**WHITE LAKE TOWNSHIP
INTER-OFFICE MEMORANDUM
COMMUNITY DEVELOPMENT DEPARTMENT**

**SUBJECT: Ginko Self Storage
Amended Final Site Plan**
located on the north side of White Lake Road, west of Old White Lake Road, consisting of 2.14 acres. Currently zoned Light Manufacturing (LM). Identified as vacant parcel 12-01-127-004
Applicant: Ginko Investments, LLC

RE: **Ginko Self Storage -Final Site Plan/Final Engineering Plan Review-4th Review**
~~Stormwater Maintenance Agreement Review-1st Review~~

Revised Final Site Plan Review for Special Land Use for White Lake Charter Township, Michigan

RED LINED
PLAN SHEET
TO
ACCOMPANY
REVIEW.04

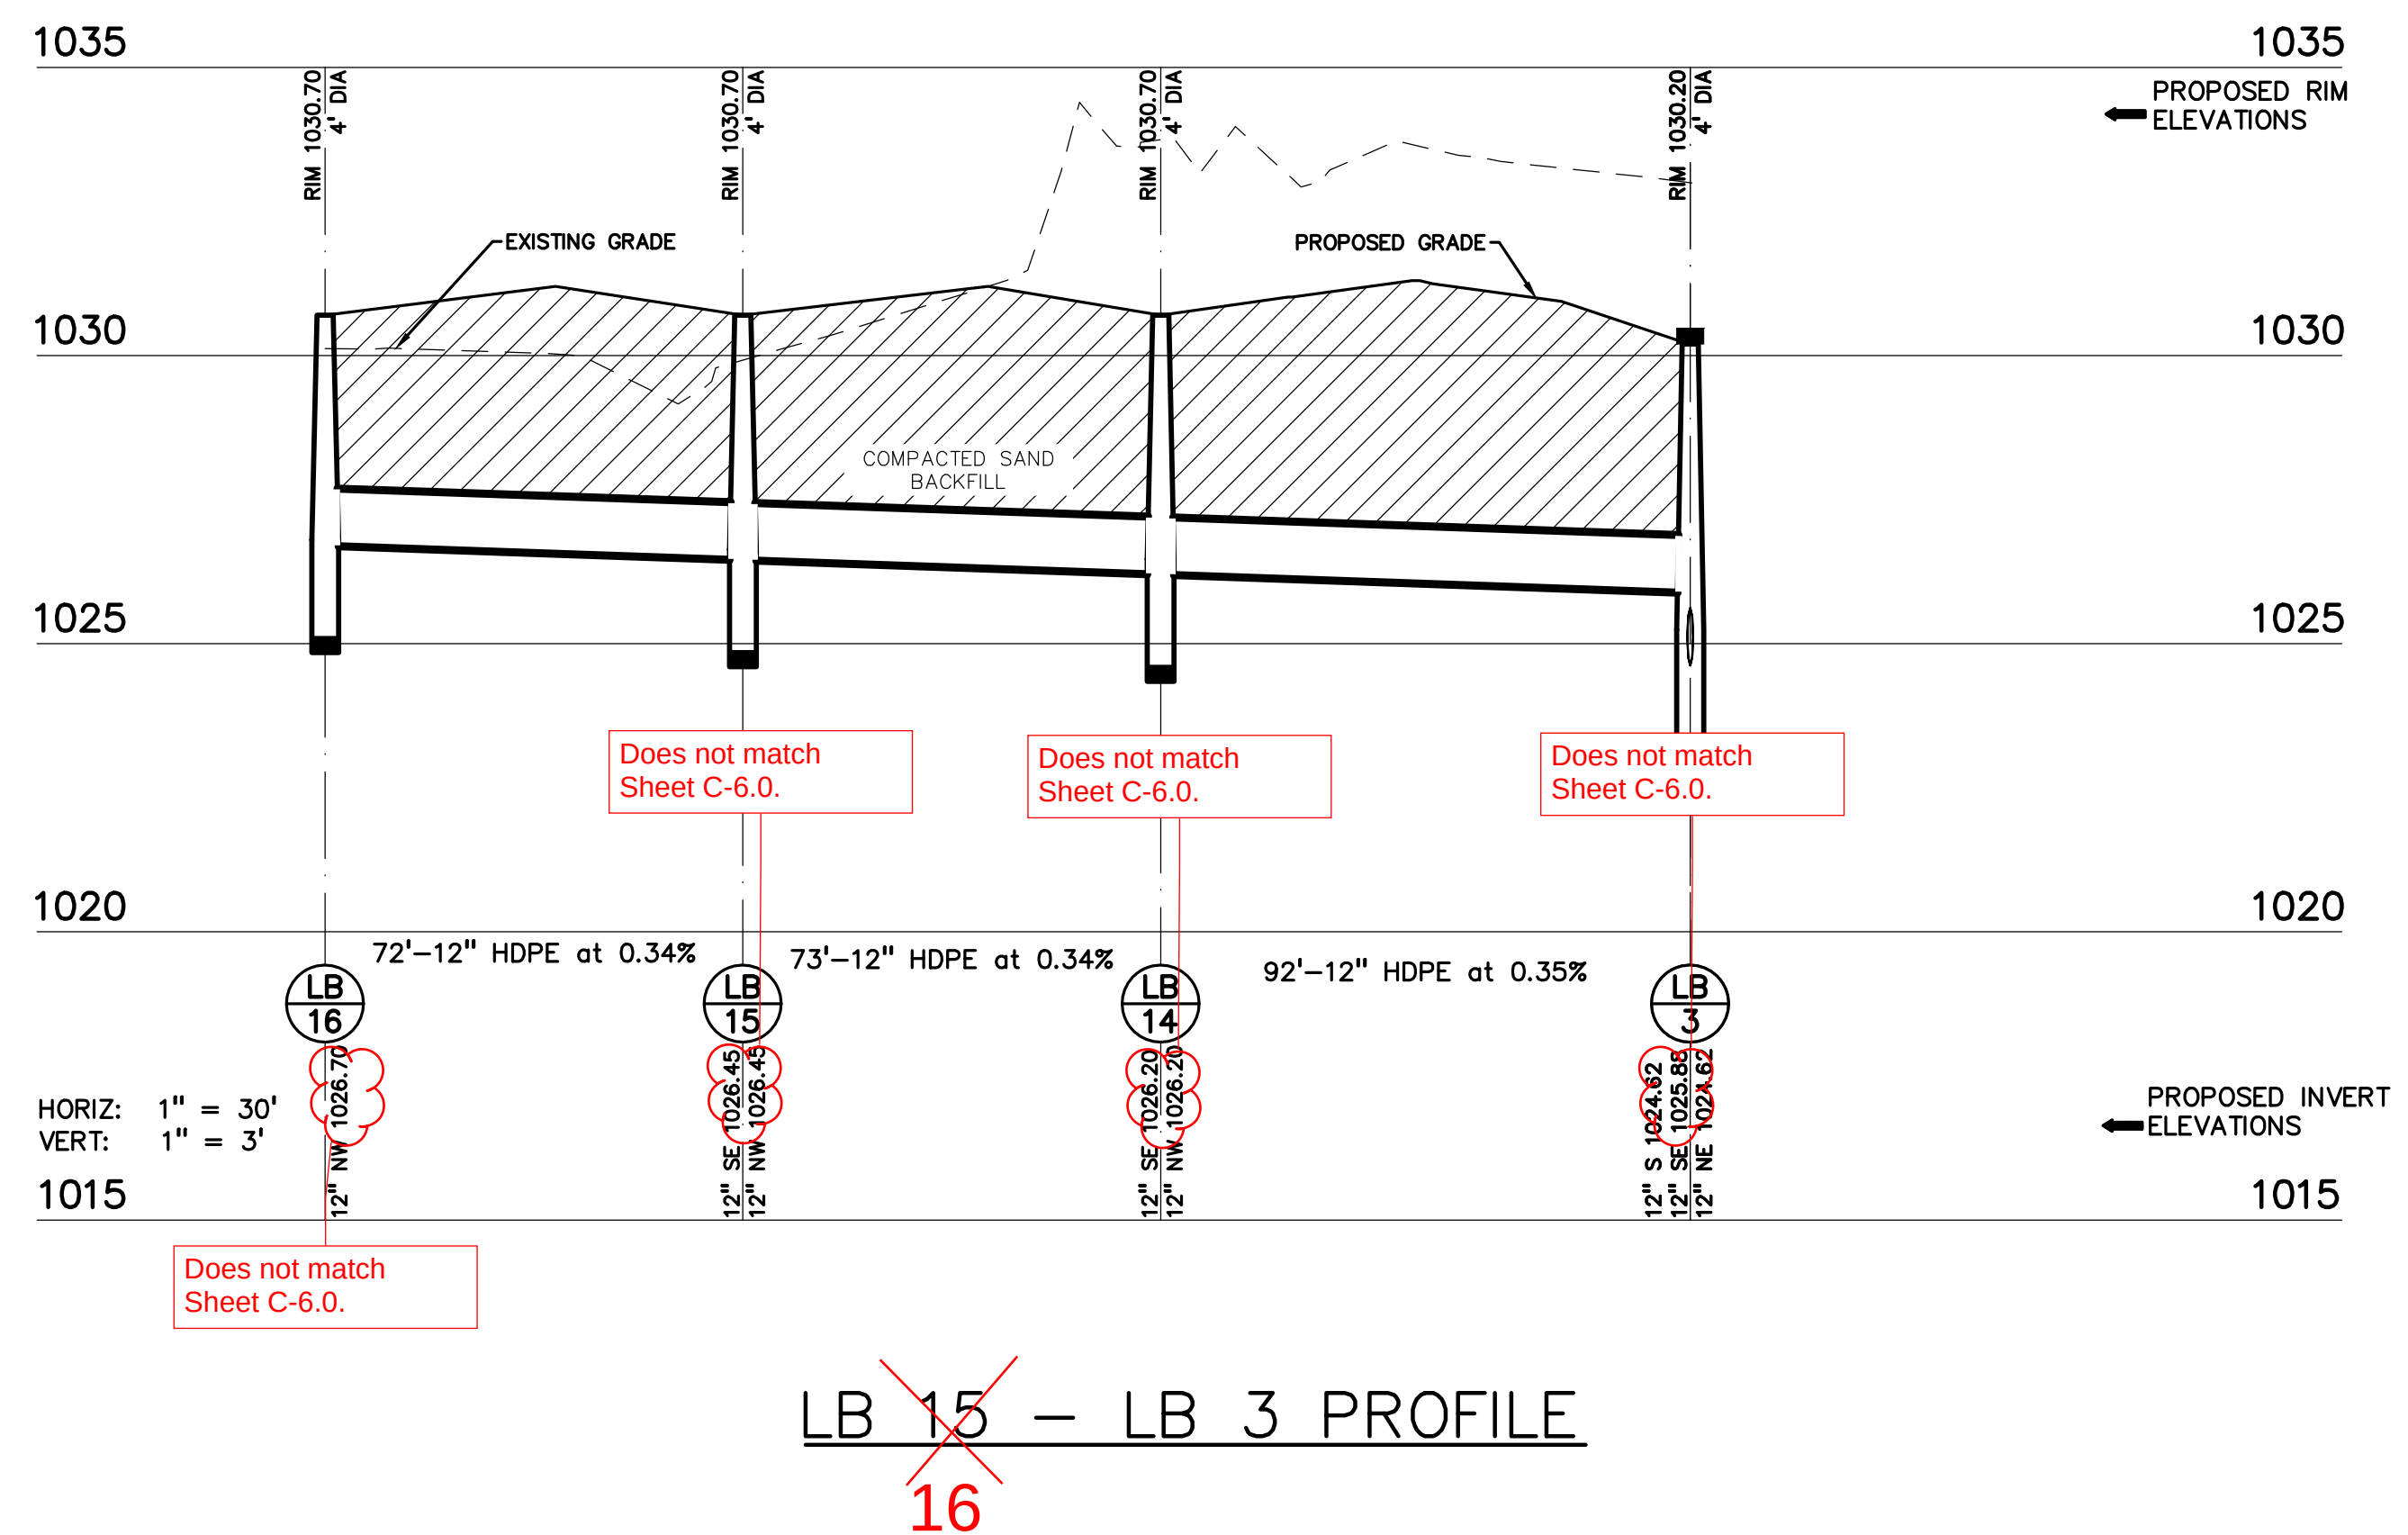
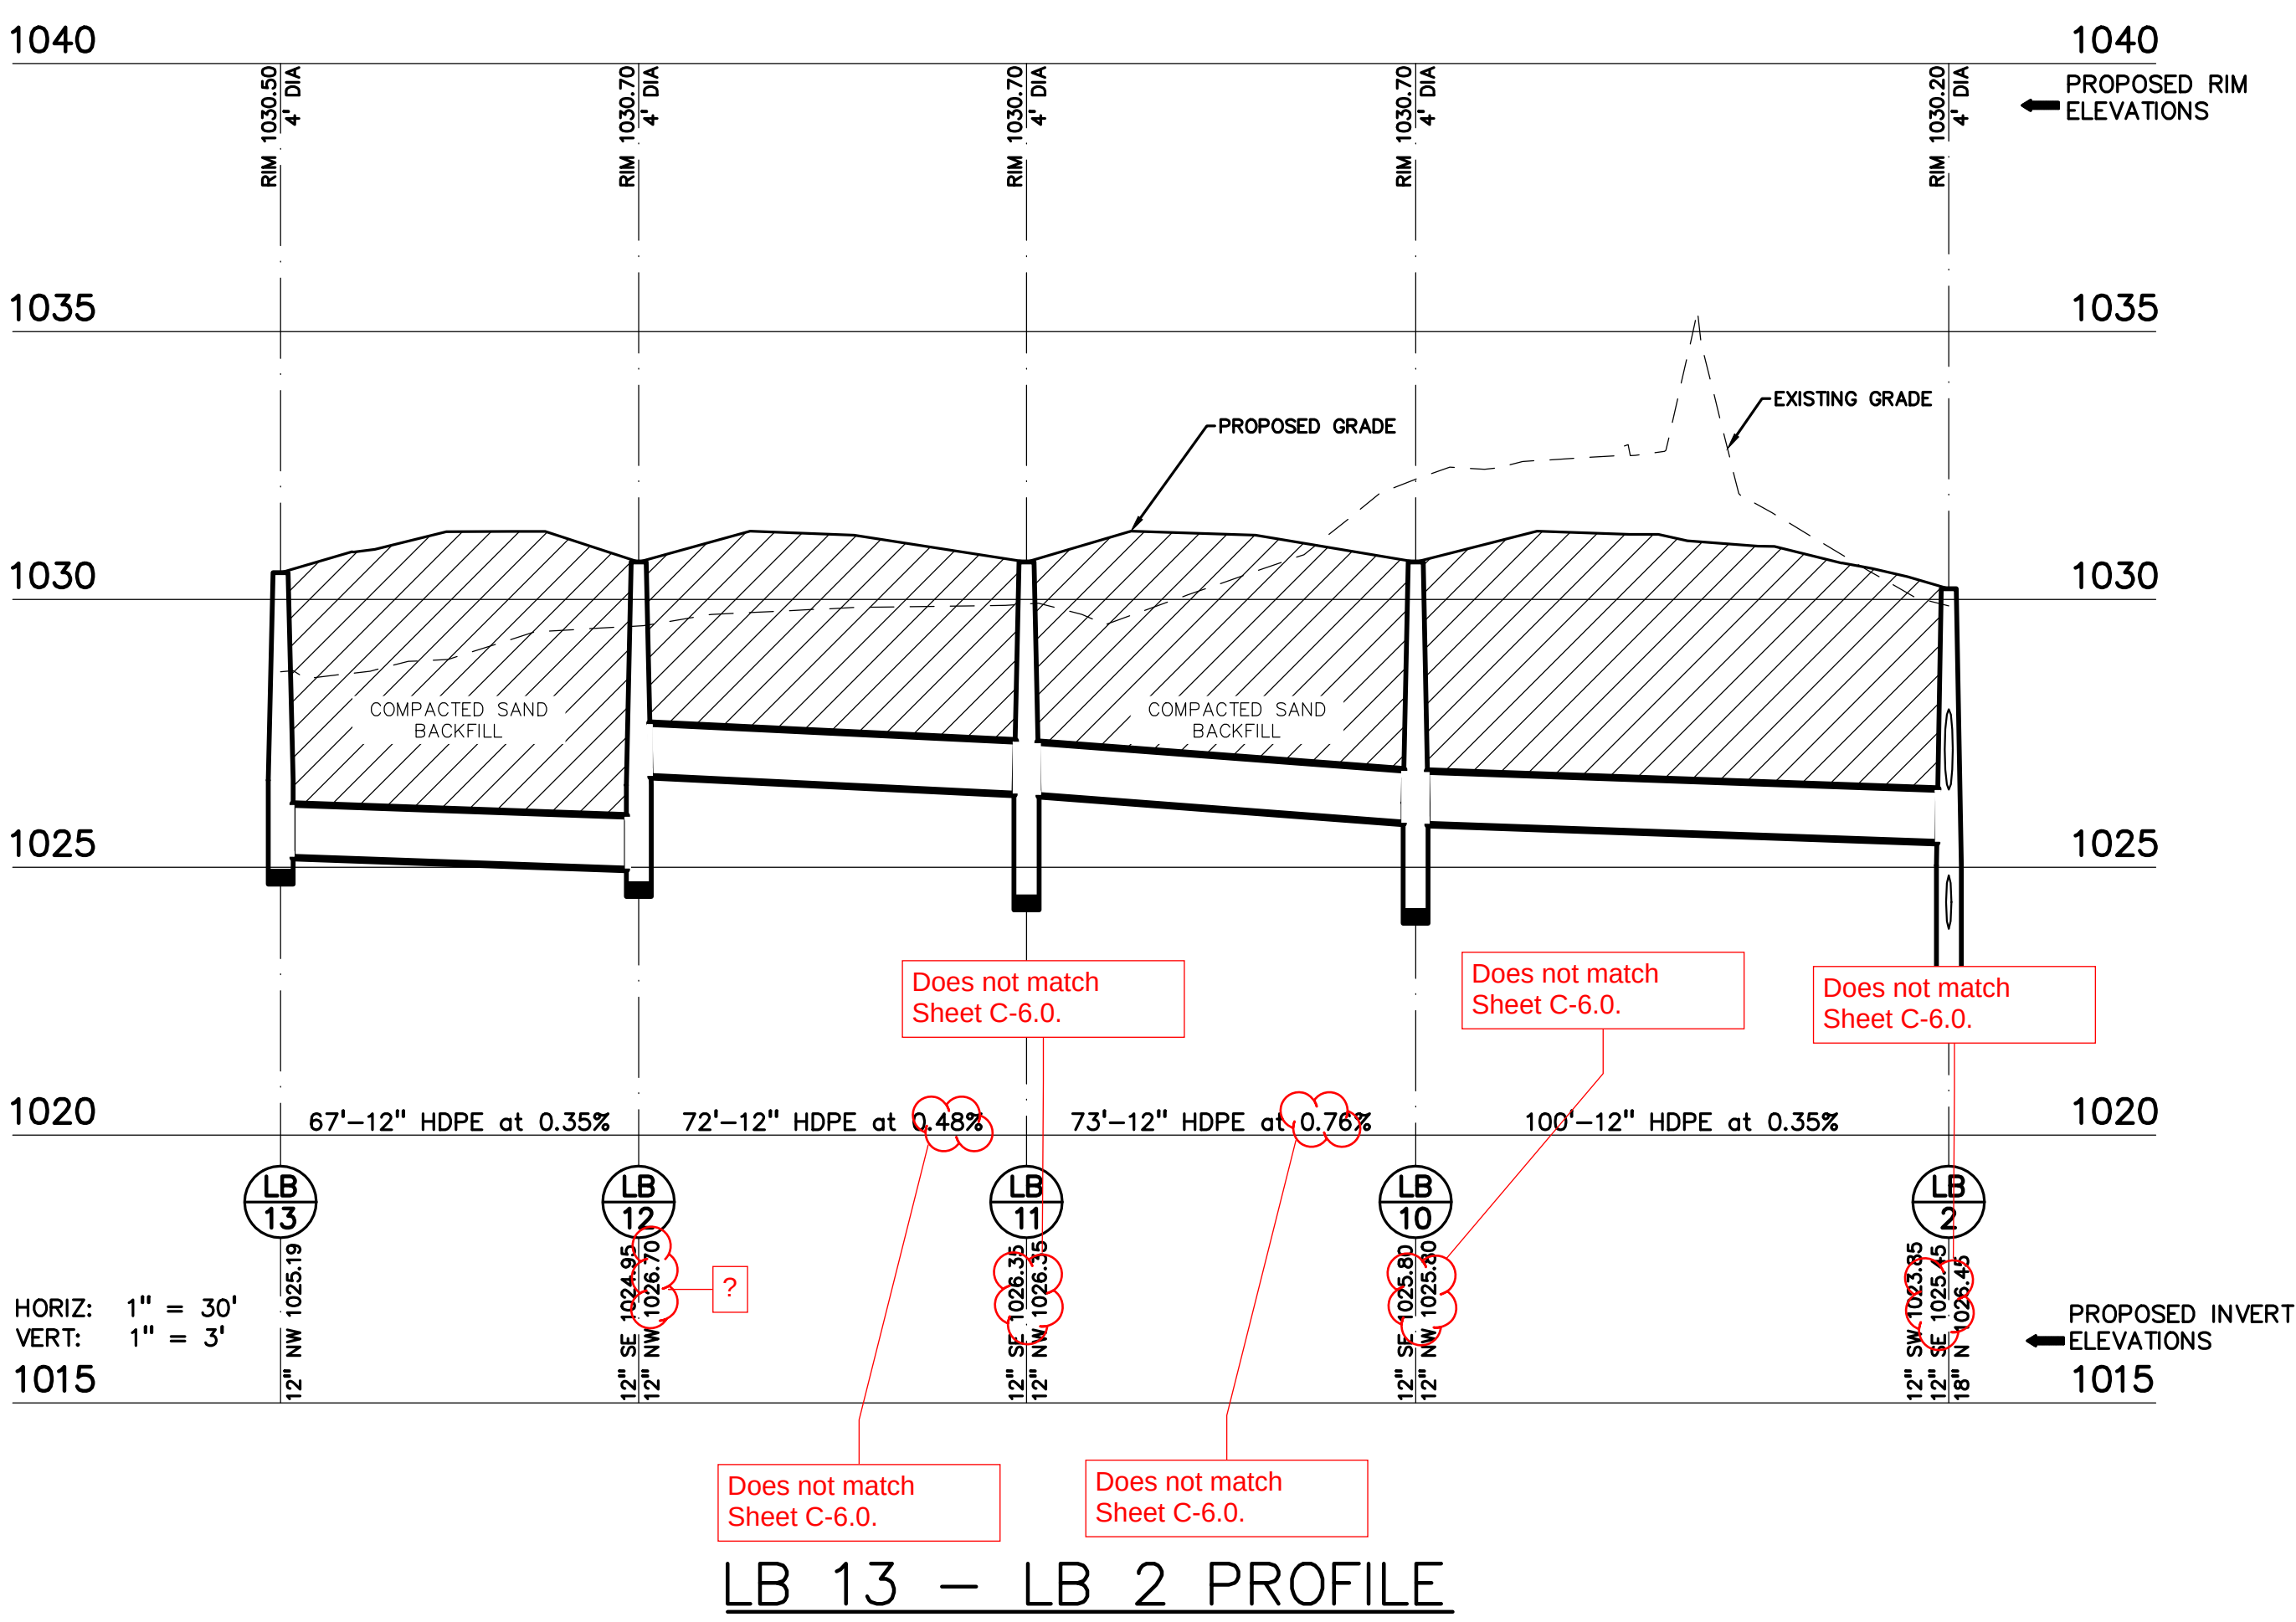
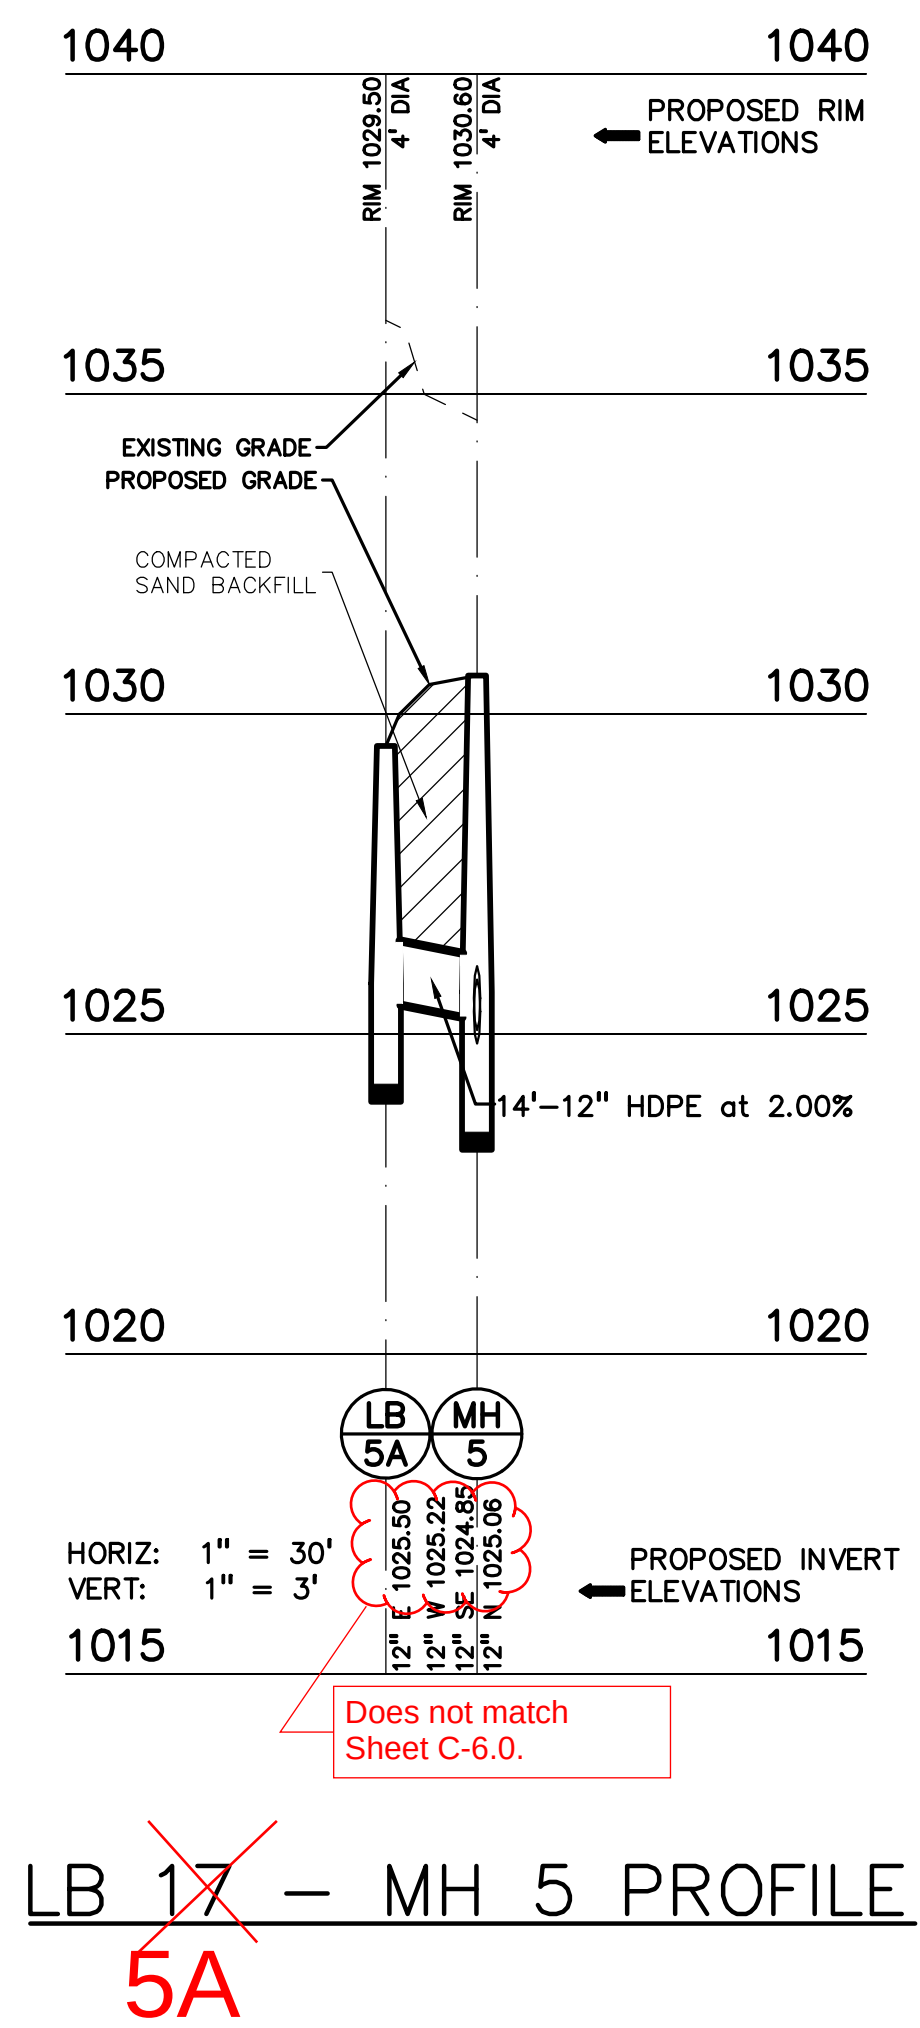
3. Sheet C-7.0- It appears that profiles were not updated based on revised storm sewer structure rim and invert elevations. We have attached a red lined copy of this sheet.
